Item ID: D206-781-041 Accept ***N900040100*** Setup Start ***NS1***
Revision ID: Stop ***NS2***
Item Name: Baggage Compartment Protector - Wall
Start Date: 12/19/2016 Start Qty: 1.00 ***1*** Cust Item ID:
Required Date: 12/22/2016 Req'd Qty: 1.00 ***1*** Customer:
Reference:

DART SERVICE INSTRUCTION

TO AMEND INSTALLATION INSTRUCTIONS IIN-D407-781-2 REV. A OR LATER APPROVED REVISION
AND INSTRUCTIONS FOR CONTINUED AIRWORTHINESS ICA-D407-781 REV. 3 OR LATER REVISION

A	NEW ISSUE		13.04.08
REV.		DESCRIPTION	BY DATE
DESIGN			
DRAWN			
CHECKED			
MFG. APPR.	N/A		
APPROVED			
DE APPR.			
DATE	13.04.08		
		DART AEROSPACE LTD HAWKESBURY, ONTARIO, CANADA	
		DRAWING NO. DSI 9649	REV. A SHEET 1 OF 2
		TITLE ALTERNATE INSTALL	SCALE NTS
COPYRIGHT © 2013 BY DART AEROSPACE LTD. THIS DOCUMENT IS PRIVATE AND CONFIDENTIAL AND IS SUPPLIED ON THE EXPRESS CONDITION THAT IT IS NOT TO BE USED FOR ANY PURPOSE OR COPIED OR COMMUNICATED TO ANY OTHER PERSON WITHOUT WRITTEN PERMISSION FROM DART AEROSPACE LTD.

FIGURE 1 - D3879-1 BAGGAGE COMPARTMENT WALL PROTECTOR - ALTERNATE INSTALLATION

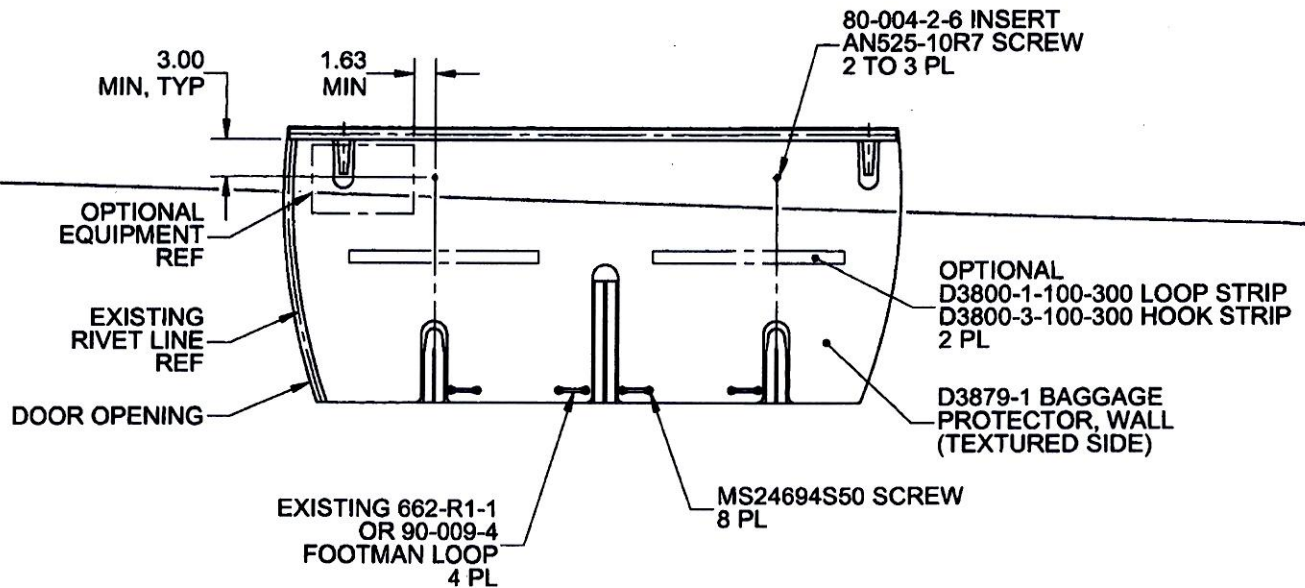
In some aircraft, the top portion of the D206-781-041 Baggage Compartment Wall Protector Kit cannot be installed as indicated in IIN-D407-781-2. The purpose of this DSI is to provide an alternate mounting method to fasten the top portion of the D206-781-041 Baggage Compartment Wall Protector Kit.

It is acceptable to replace qty(2) D3930-1 Clips with qty(2) 80-004-2-6 Inserts. Locate and mark location of the two attachment holes on the baggage compartment wall as shown in Figure 1 of this service instruction. Install 80-004-2-6 Inserts at the marked locations in accordance with Section 3-2-12 of BHT-206-SRM-1. It is acceptable to trim the wall protectors to accommodate optional equipment or transfer attachment holes to the wall protector and install the optional equipment on top of the wall protector with longer fasteners.

Amend the D206-781-041 Baggage Compartment Wall Protector Kit parts list as follows:

Qty -061	Qty -031	Qty -041	Part Number	Description
X			D206-781-061	BAGGAGE COMPARTMENT PROTECTOR KIT (FLOOR AND WALL)
1	X		D206-781-031	BAGGAGE COMPARTMENT FLOOR PROTECTOR KIT
1		X	D206-781-041	BAGGAGE COMPARTMENT WALL PROTECTOR KIT
		2	AN525-10R7	SCREW
		2	80-004-2-6	INSERT
